Santos Titleholder Report on Public Comments

Santos WA Northwest Pty Ltd (Santos) proposes to drill up to seven (7) exploration and/or appraisal wells in Commonwealth waters within the Bedout Basin. The *Bedout Multi-Well Exploration and Appraisal Drilling Environment Plan (EP)* will cover drilling, evaluating, well testing and abandonment activities related to proposed exploration and appraisal drilling.

Table 2: Public comments received and titleholder response

ARA - Socio-economic EMBA, Ecological EMBA and Deterministic Run Model

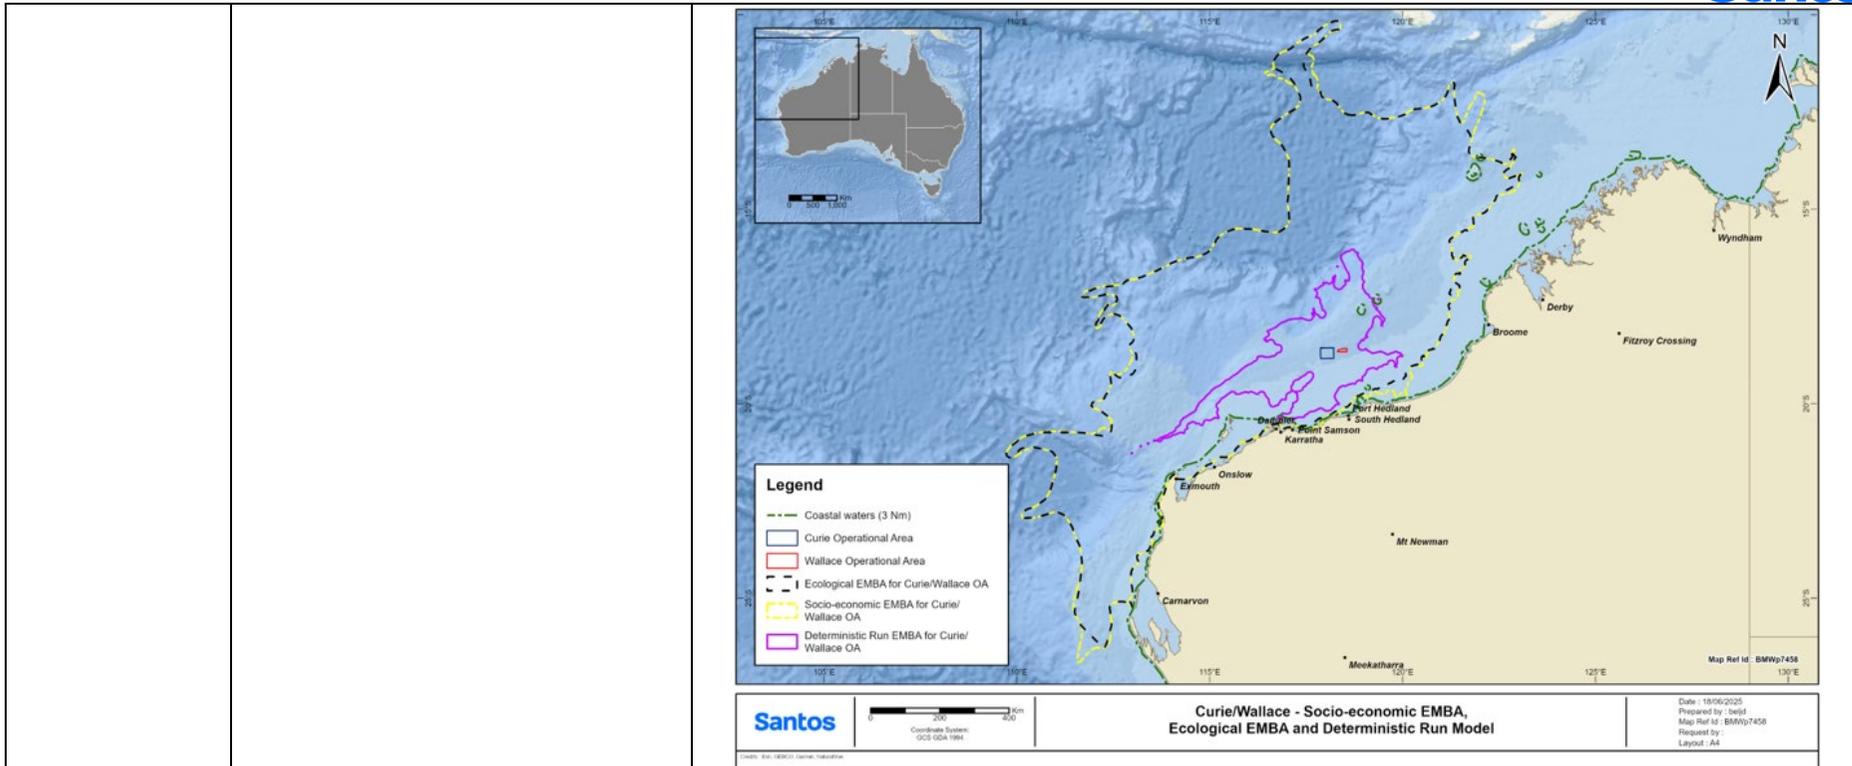
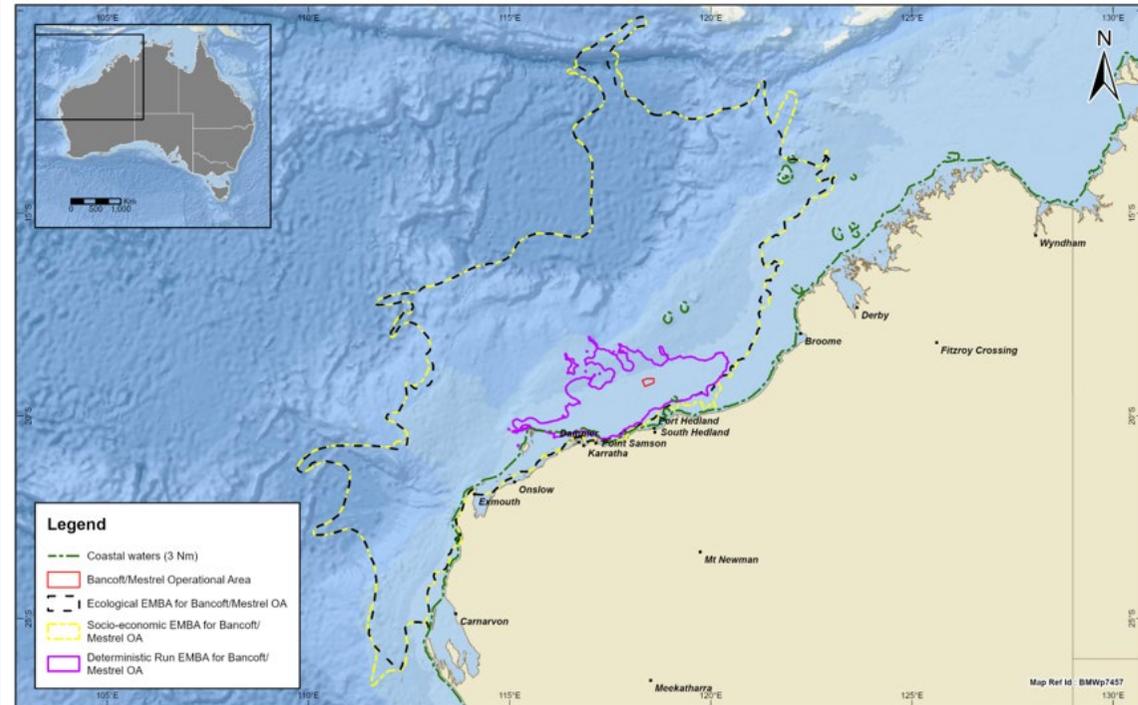
<p>5BIO</p>	<ul style="list-style-type: none"> • <i>Claim: The EP fails to adequately manage spill risks through robust</i> 	<p>Santos notes the claims regarding proximity to areas of environmental and cultural sensitivity (including, world heritage listed areas, Commonwealth and WA State marine parks) and has reviewed the EP to</p>
--------------------	--	---

<p><i>prevention or mitigation, relying on modelling that inaccurately defines the EMBA and overlooks worst-case scenarios.</i></p> <ul style="list-style-type: none"> • <i>Claim: The proposal poses unacceptable risks of oil spills which could impact World Heritage Areas, and areas of high environmental, biological, cultural and economic significance for West Australians within the proposals ‘environment that may be affected’.</i> • <i>Claim: Santos assumes that marine mammals can simply “move away” from an oil spill, despite the fact that a worst-case scenario oil spill would reach over 1,500 km in length and over 500 km in width if it were to occur.</i> • <i>Claim: This proposal occurs in waters adjacent to internationally significant marine ecosystems.</i> • <i>Claim: Inadequate consideration of potential oil spill impacts to reefs.</i> • <i>Claim: Inconsistent with Recovery Plans or threat abatement plans.</i> • <i>Claim: Impact to dusky sea snakes and marine reptiles</i> 	<p>ensure that this matter is appropriately considered and addressed. Revisions to the EP, where required, are set out below.</p> <p>The maps in the EP (Figure 3-1) showing the Environment That May Affected (EMBA) shows the largest area where all modelled spills could have a potential environmental consequence – it represents the total of all possible spill scenarios, not an individual spill (see below for examples of individual spill modelling in different seasons).</p> <p>In addition, the EMBA and the examples of individual spill modelling below do not consider that the area will be reduced through implementing our spill response plan. Therefore, the area of 1,500 km in length and over 500 km in width is not the expected impact of an unplanned spill.</p> <p>The EP includes the recovery plans, conservation advice and species management plans relevant to the threatened and migratory species that have been identified as potentially occurring within the EMBA.</p> <p>A comprehensive risk and impact assessment is included in the EP. The consequence from planned activities (operational area for planned activities does not contain any sensitive habitats or significant features) is negligible to minor. The residual risk from unplanned events such as a spill is low to very low.</p> <p>Section 7.5 of the EP describes spill scenario selection and 7.6 and 7.7. of the EP addresses a LOWC event, and a hydrocarbon spill of marine diesel oil event.</p> <p>While the EMBA outlines the maximum potential spatial extent of all modelled spill scenarios, a single simulation run (i.e. deterministic) (e.g. the 1,367,291 m³ surface release of Caley crude scenario), more realistically represents a much smaller spatial footprint, and not to the spatial extent as claimed (1500 km x 500 km for a single worst-case spill).</p> <p>As described in Section 7.6 of the EP, in the event of a LOWC, the hydrocarbon released is a condensate and is expected to weather quickly through evaporation and dispersion. Section 7.6.4.2 of the EP explains the exposure durations and expected impacts to marine mammals.</p> <p>An example output of the deterministic runs (three separate figures) showing the predicted low threshold exposure area for a single simulation (winter) following a LOWC event resulting in the maximum swept area with floating oil at, or above, 50 g/m² is presented in Appendix H of the EP, as shown below:</p>

The OPGGS(E)R requires impact assessment of all potential events, including accidental unplanned events, regardless of the likelihood.

Protected and sensitive areas identified in the OAs and EMBA are listed in Table 3-6 and illustrated in Figure 3-4 to Figure 3-8 of the EP. Santos provides a summary of these areas (as described in the EP) below, noting impacts from planned activities typically occur within each OA.
